INFORMATION BULLETIN NO. 124

TO: ALL OWNERS OF FLETCHER® ROOF DRILLS WITH TRAM COMPARTMENT

SUBJECT: AUXILIARY VALVE BANK GUARD

EXAMPLE OF GUARD ON AUXILIARY VALVE BANK. YOUR MACHINE MAY LOOK DIFFERENT THAN THIS. THE CORRECT GUARD FOR YOUR MACHINE WILL BE SENT WHEN YOU PROVIDE THE SERIAL NUMBER OF YOUR MACHINE UPON ORDERING.

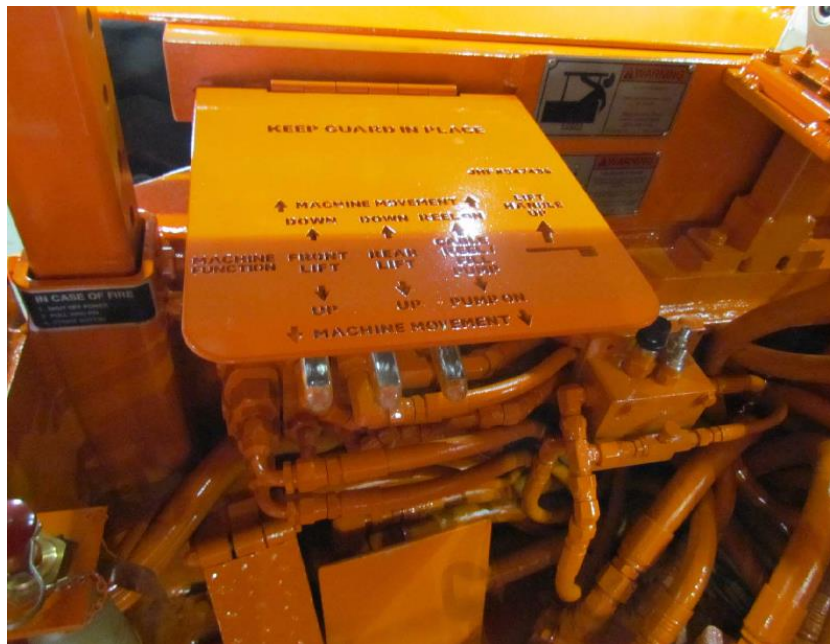
Fletcher has developed a guard for the tram deck located auxiliary control valve (see picture pg. 3). The auxiliary control valve guard should be installed on any machine where the tram canopy has been, or could possibly be, removed.

If you have removed the tram canopy from your roof drill contact Fletcher to obtain the correct auxiliary valve guard for your machine. This guard should be installed above the auxiliary control valve levers (see photo) at the specified distance from the levers. This guard is a substitute for the protection ordinarily afforded by the tram canopy.

3. Install the guard above the valve bank in accordance with Fletcher's installation instructions. The guard should be installed at a specified distance in relation to the control valves as set forth in the specific installation instructions. Confirm that the directional control for each lever matches the engraving on the guard for each control lever.
